CORRECTIONS

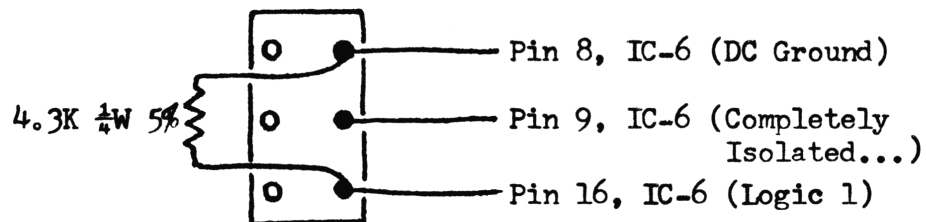
SCB Vol. 21, pg 18: 10KHz Jump Mod. Add....  
ADD.... solder 4.3K  $\frac{1}{4}$ W 5% resistor from  
pin 8 to pin 9 of IC-6. OR add at the  
switch modification as shown below.
